**Consumers
Power
Company**

March 23, 1976

DOCKET 50-255, LICENSE DPR-20
PALISADES PLANT, ANSWER TO
QUESTION ON LOCA (4.A.7)

Question 4.A.7

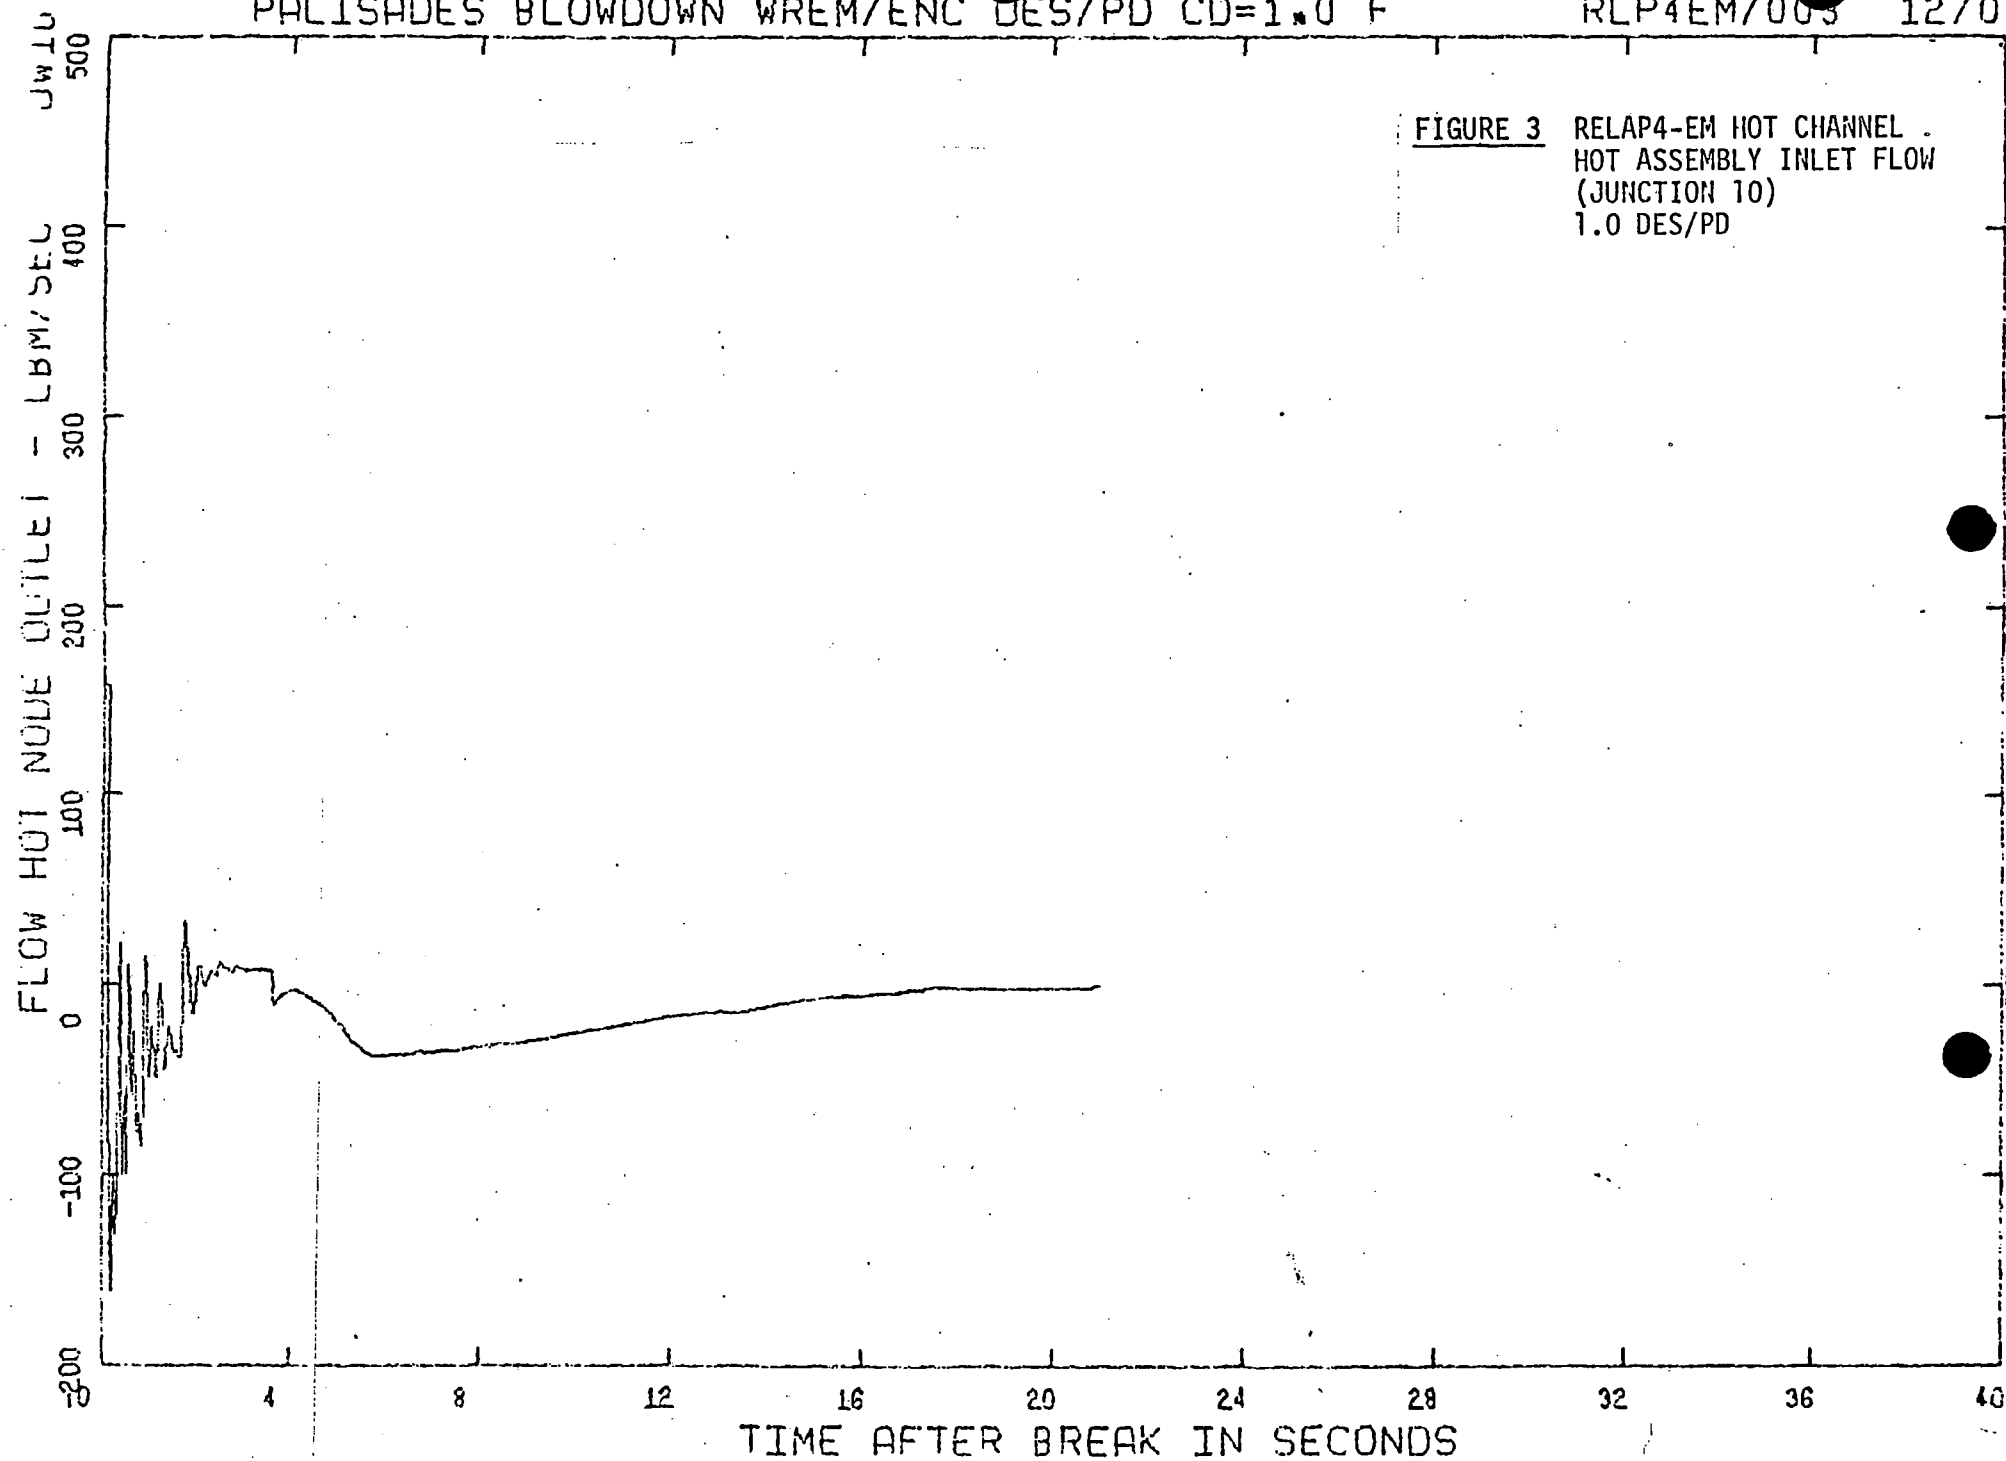
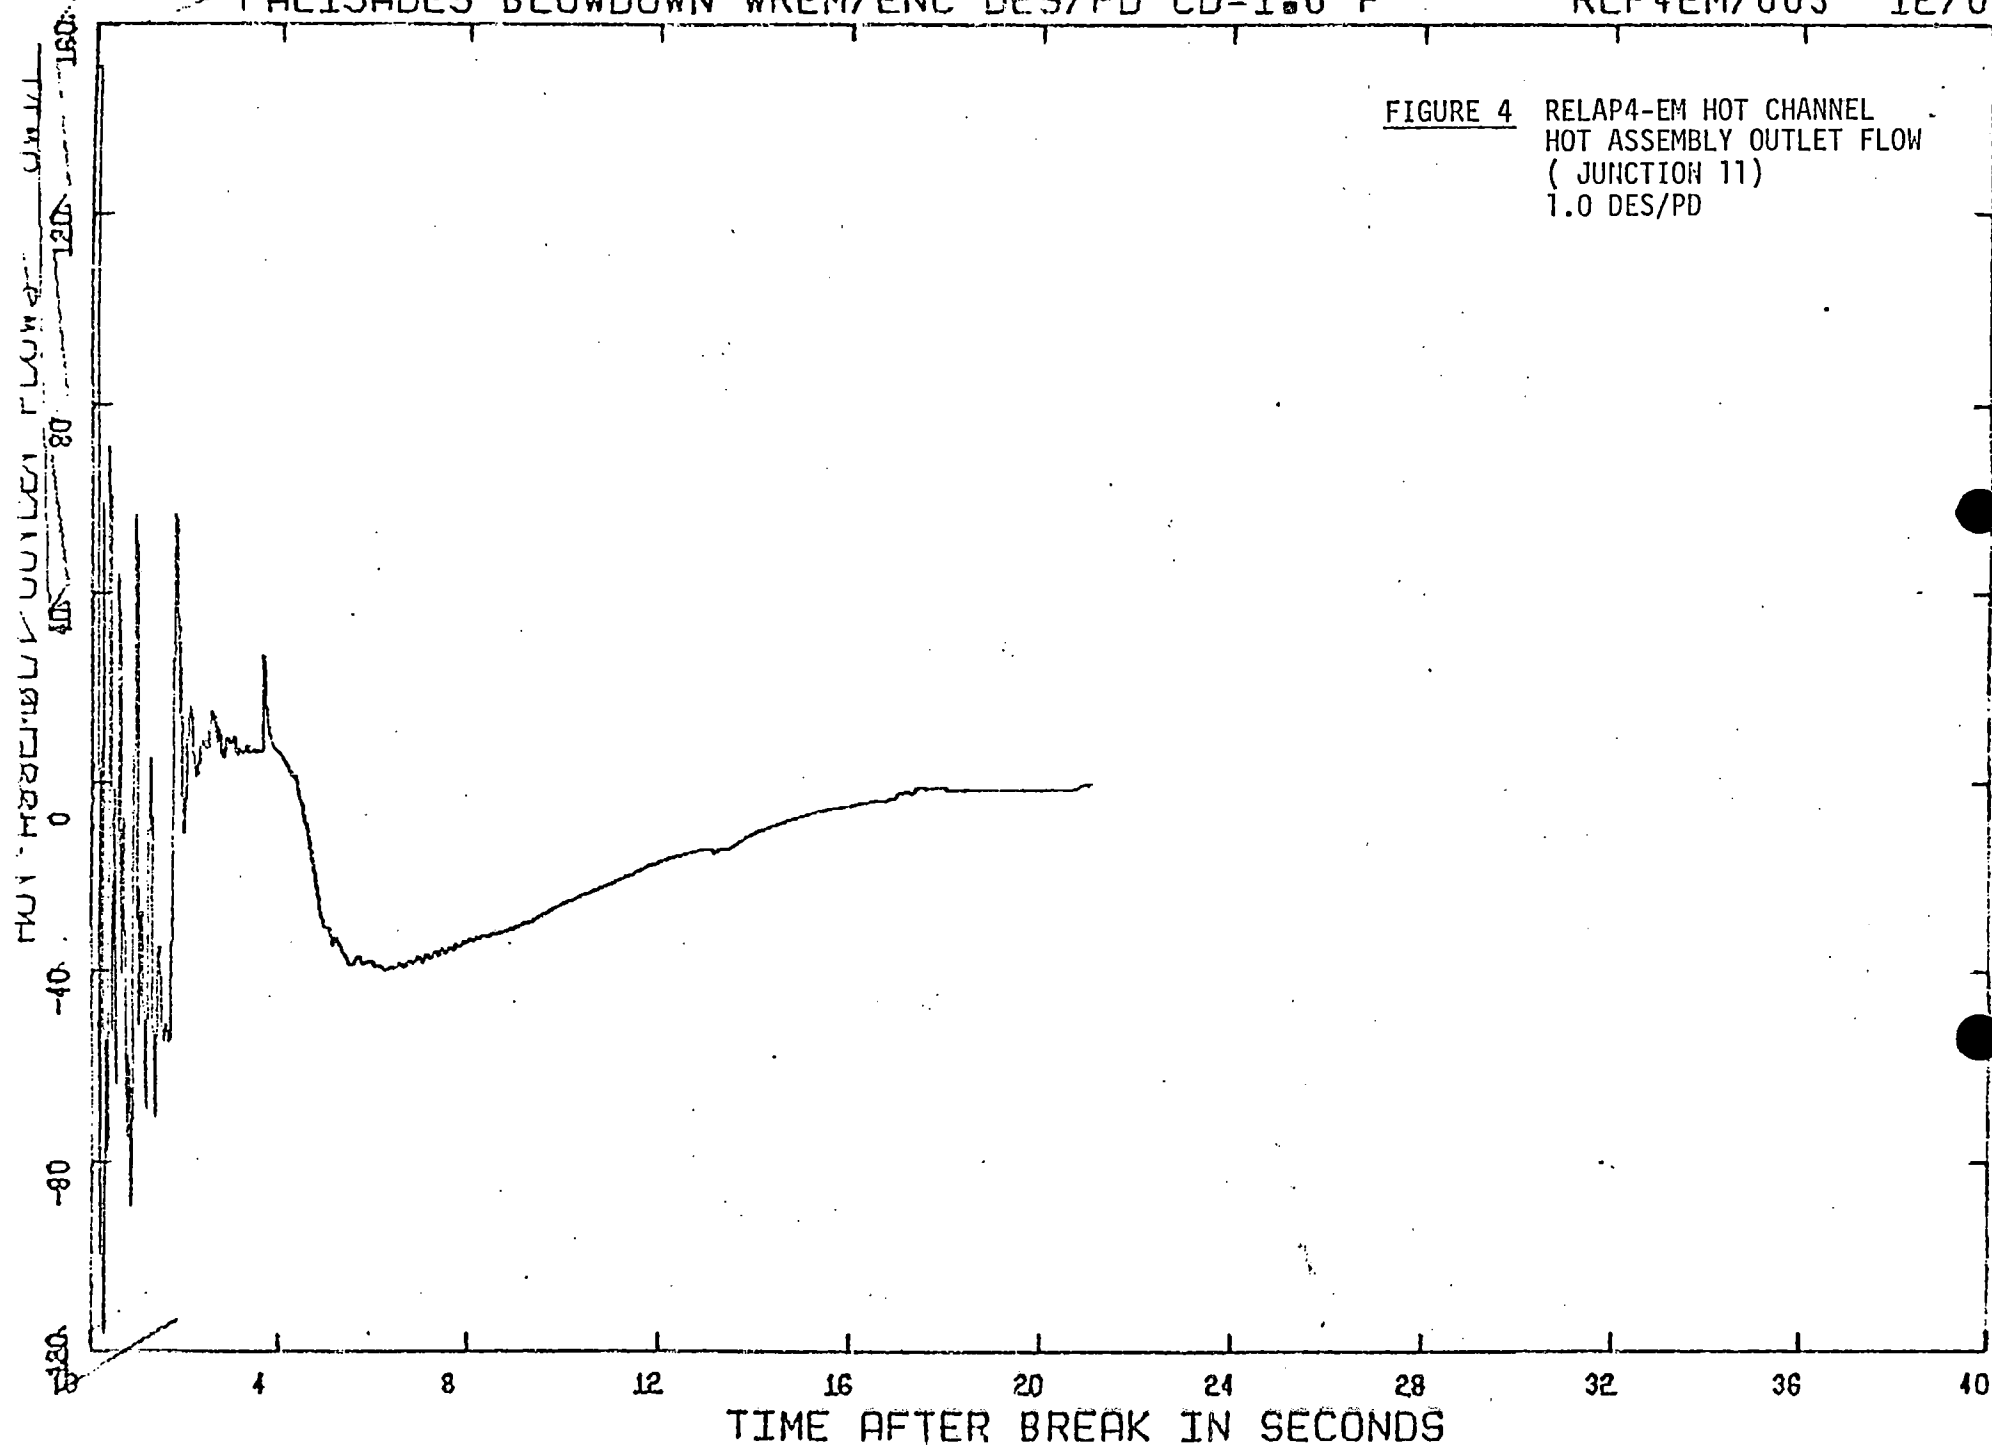
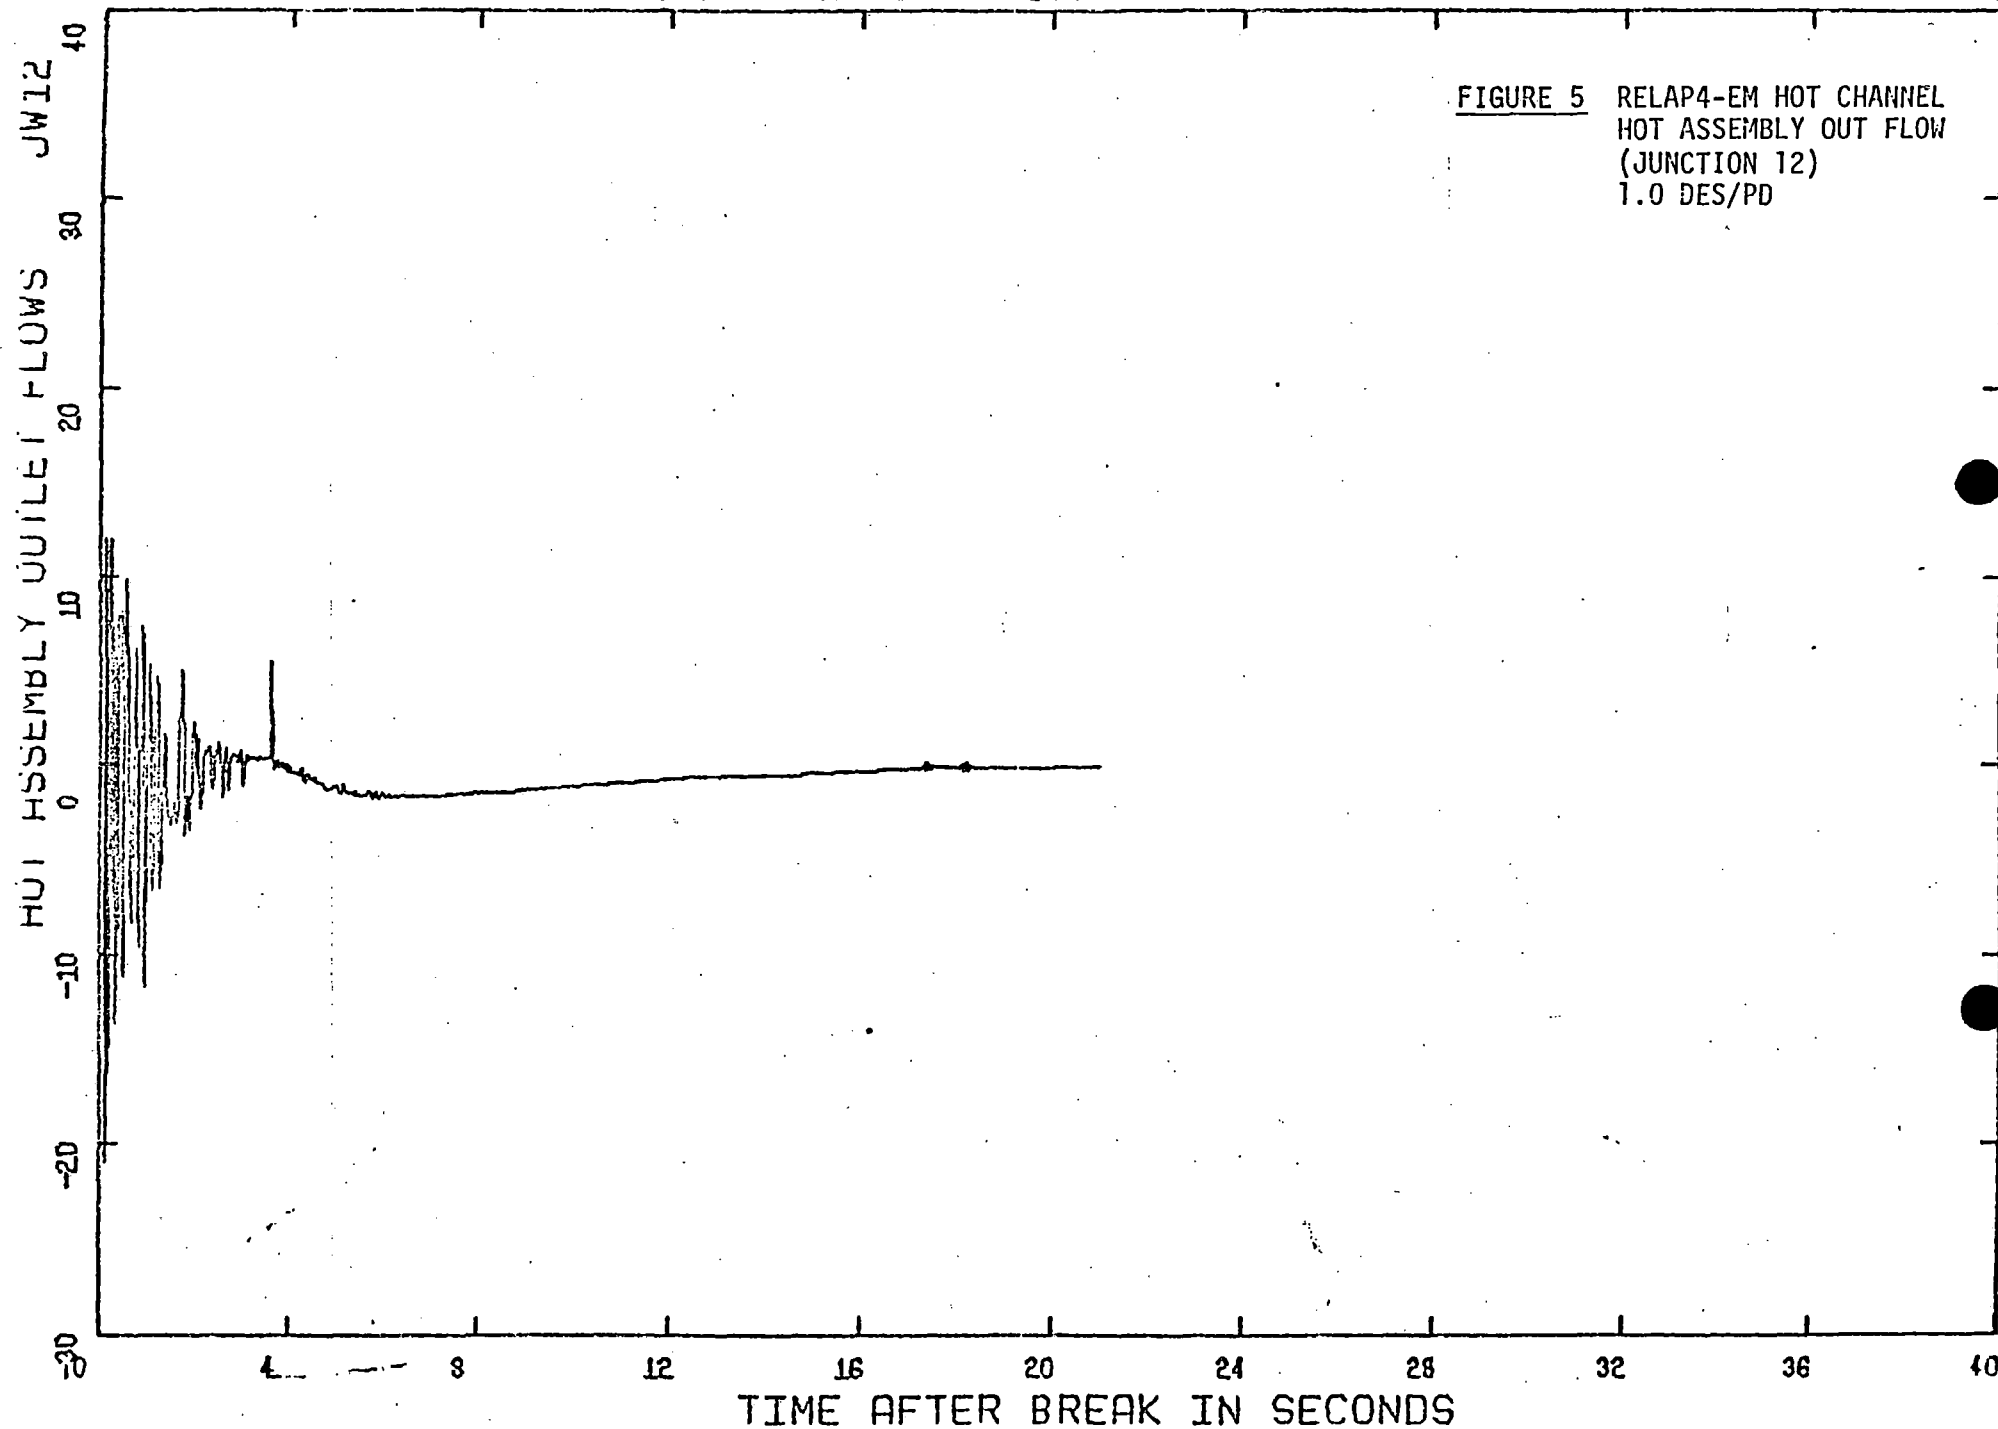
1. Reactor coolant temperature versus time at the hot spot.
2. Average fuel temperature at the hot spot.
3. Hot assembly flow rate.
4. Quality at the hot spot.
5. Gap conductance versus time at hot spot.
6. Hot rod internal pressure.
7. Rupture time.

1. The average fluid temperature in Volume 6 of the hot channel model (Figure 1).
2. The volumetric average fuel rod temperature for heat transfer Node 22 of the hot channel model (Figure 2).
3. Hot assembly flows at inlet Junction 10 and outlet Junctions 11 and 12 for the hot channel model (Figures 3, 4 and 5).
4. Average quality of Volume 6 of the hot channel model (Figure 6).
5. Gap conductance for the maximum power node for both blowdown and reflood and gap conductance for the PCT node during refill and reflood (Figures 7 and 8).
6. The hot rod pin pressure during the entire transient (Figure 9).
7. Rupture time for the 1.0 DES/PD was calculated to occur at 49.82 seconds after the break.
